Appeal No: ACP -323120-25

Applicant's response to appeals

RE: RESPONSE TO THIRD PARTY APPEAL IN RESPECT DEMOLITION OF BUILDINGS/STRUCTURES AND CONSTRUCTION OF A 14 STOREY BUILDING INCLUDING OFFICE USE, ARTS CENTRE AND CAFÉ, AUDITORIUM, AND ANCILLARY USES AT SITE BOUND BY CITY QUAY TO THE NORTH, MOSS STREET TO THE WEST & GLOUCESTER STREET SOUTH TO THE SOUTH, DUBLIN 2. THE SITE INCLUDES 1-4 CITY QUAY (D02 PC03), 5 CITY QUAY AND 23-25 MOSS STREET (D02 F854).

Figure 2.8: Extract from Solearth report (12 noon, May 21st). The conflicting shadow directions indicate a time discrepancy between the images.

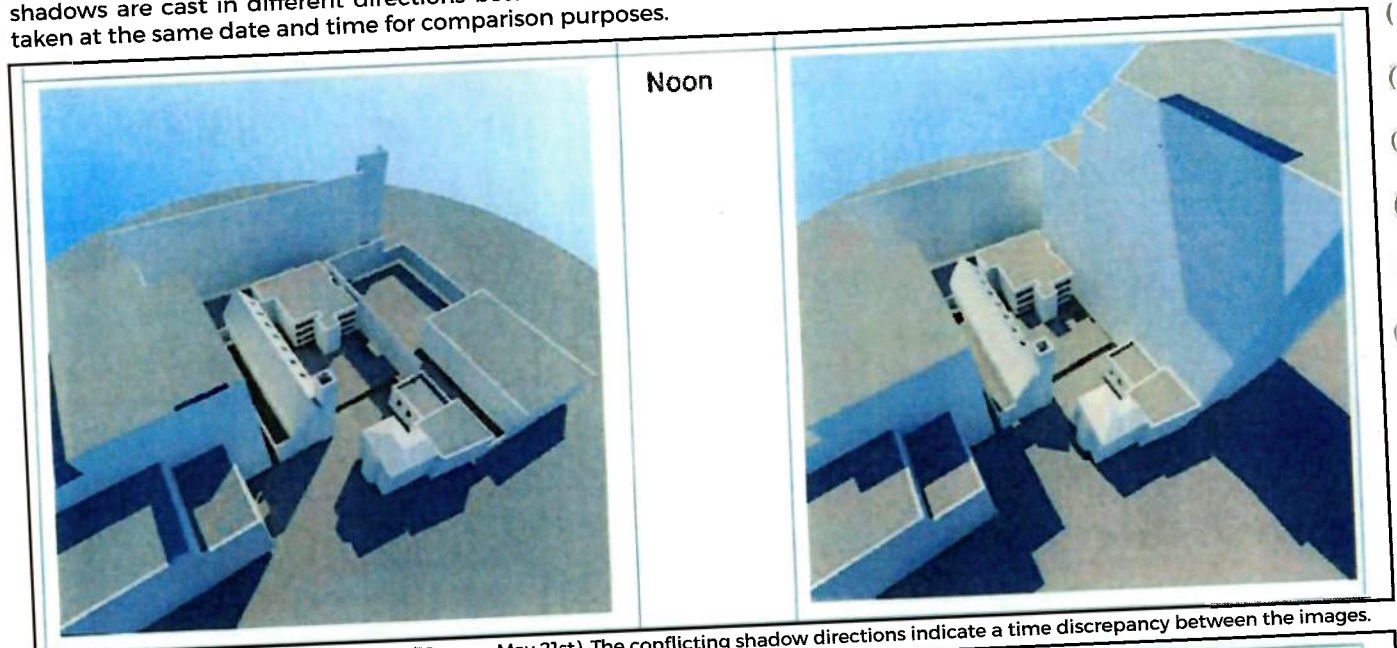
The shadow simulations in the Solearth report compare the baseline and proposed conditions. However, as demonstrated by the following extracts, the published renders are not taken at consistent times. This is evident by the fact that projected shadows are cast in different directions between the baseline and proposed representations that are supposed to be taken at the same date and time for comparison purposes.

Figure 2.9: Extract from Solearth report (2pm, May 21st). The conflicting shadow directions indicate a time discrepancy between the images.

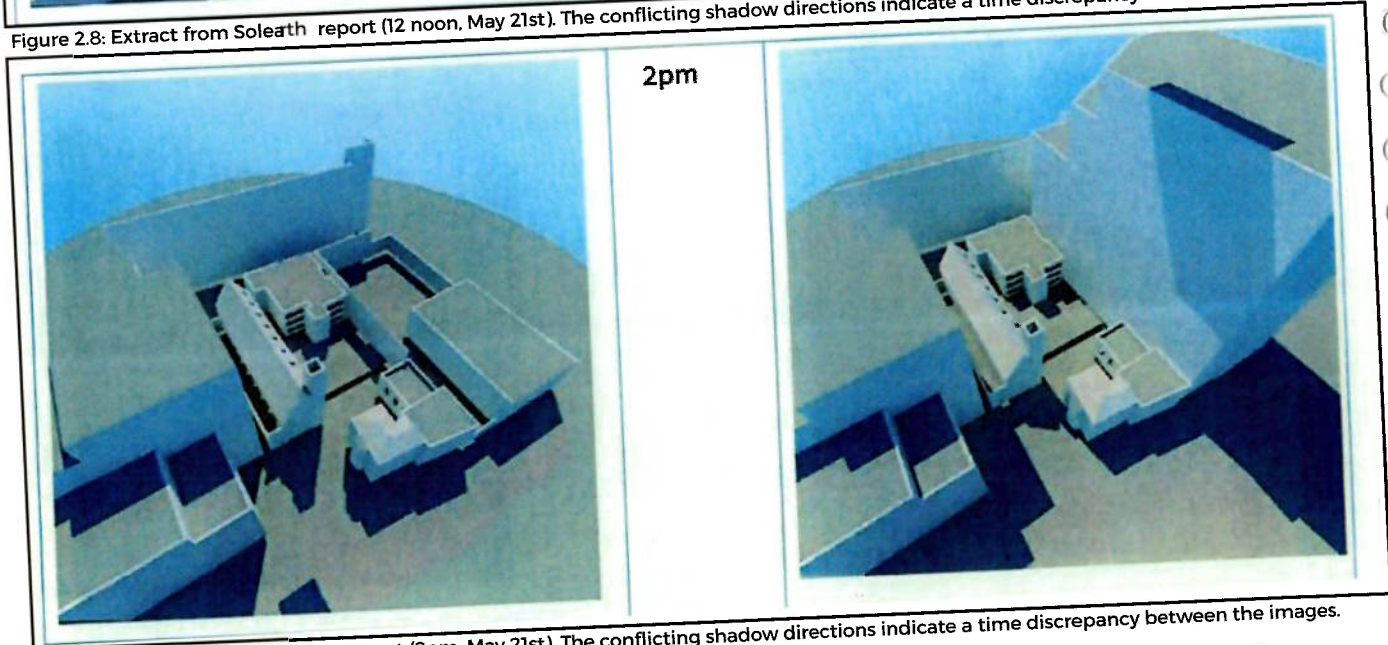
This inconsistency means that a direct and meaningful comparison between the baseline and proposed conditions cannot be made from their study.

Figure 3.8: 3DDB APSH view image from window 2c with George's Quay House and 1GQ highlighted in Red (R). Solearth model view with indication of omission of George's Quay House and 1GQ from the assessment model (L).

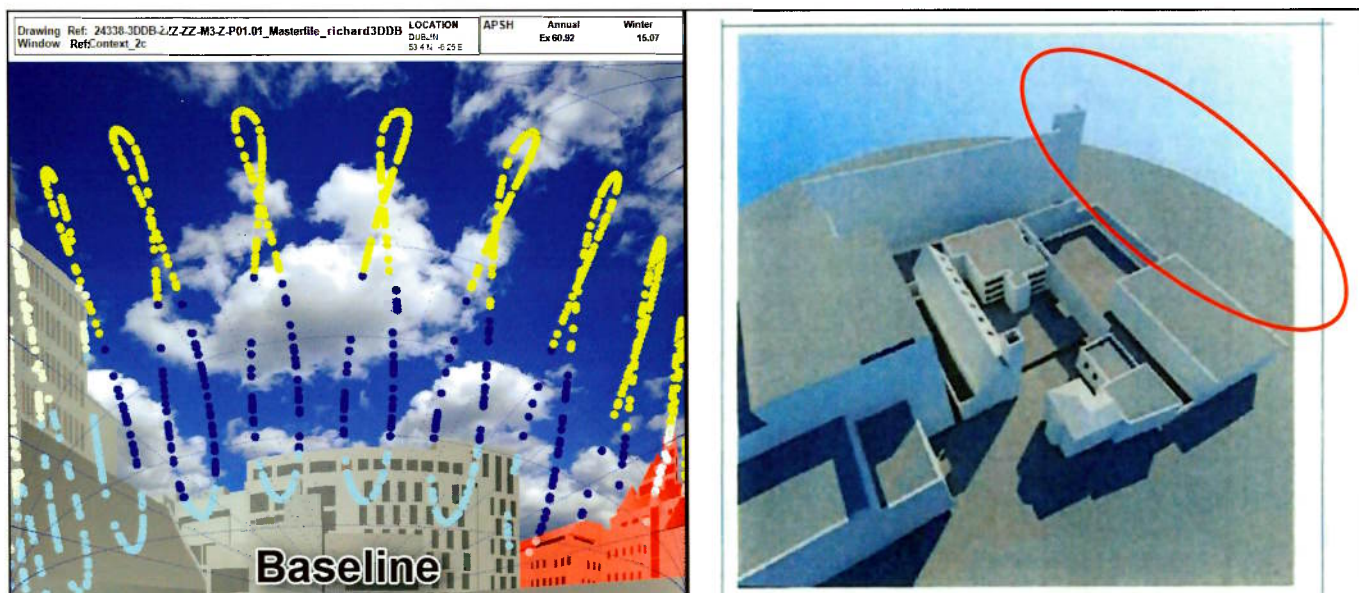
Conversely, the figures published for the same window in the Solearth report indicate a baseline APSH value of just 31.24%. Considering the recommended minimum is 25.00%, this value seems unexpectedly low, especially as Solearth has used a more favourable orientation of 181° for this window. Furthermore, as demonstrated in Figure 3.8, the Solearth model is missing context that would obstruct sunlight in the baseline state.

These identifiable discrepancies between the two analytical models (a more favourable orientation and missing obstructions) should have resulted in a higher baseline value in the Solearth report. However, their baseline APSH figure is notably lower than that in the 3DDB report.

Figure 5.1: Section comparing impact angles on the church: Subject Application vs. Grant Thornton Building

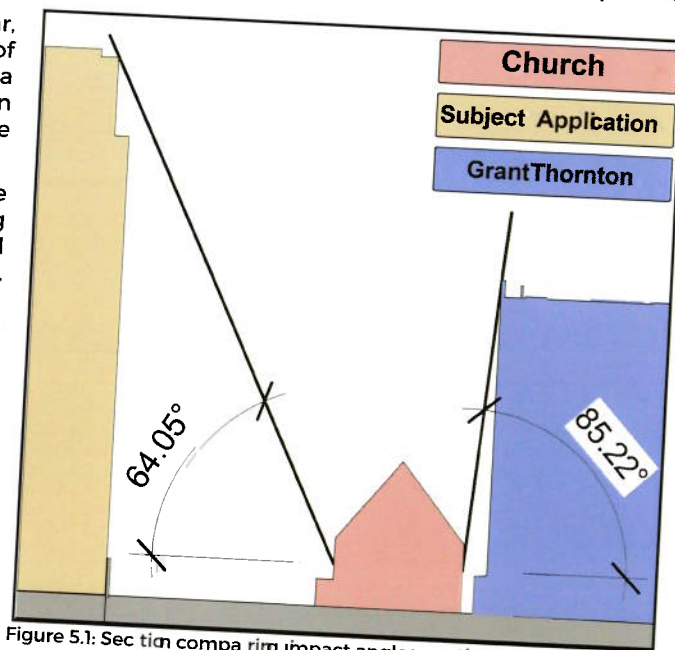
Secondly, the conclusion that "All windows of The Immaculate Heart of Mary church suffer losses in their daylight" is misleading and factually incorrect. In addition to the three unassessed windows on the western elevation, windows on the north, east, and south facades would also be unaffected. The conclusion should have been limited to state that 'all assessed windows are affected'.

Furthermore, in terms of a precedent for accepted impact to a church, one needs to look no further than the east elevation of Immaculate Heart of Mary Church. In March 2016 permission was granted for the construction of a five to nine storey, mixed-use building (DCC Reg. Ref. 2407/15), known as "The Grant Thornton Building". Although this development is not as tall as that of the subject application, it is in closer proximity to the church. Consequently, as demonstrated in Figure 5.1, The Grant Thornton Building has a far greater impact on the windows of the church than the subject application.
